Rezoning Transportation Analysis

Petition Number: 2023-068

Date	Description
8-24-23	First Review (JP)

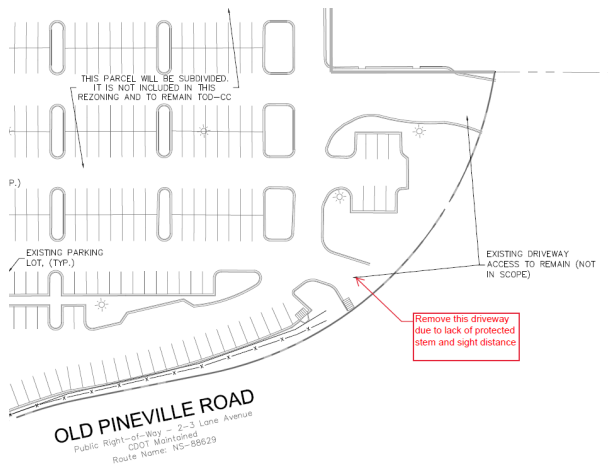
1. Curblines:

- a. **Arrowood Road:** Location of future curb and gutter to be moved to 27 feet from roadway centerline to the back of curb to accommodate the Charlotte Streets Map with a roadway typical section of a 2+ Avenue with buffered bike lanes.

- b. **Old Pineville Road:** The future location of curb and gutter is in its existing location.

NOTE: Additional distance from center line to back of curb may be required in locations where a median is present or around intersections and interchanges.

Label and dimension the curb and gutter from the centerline for each road on the site plan.
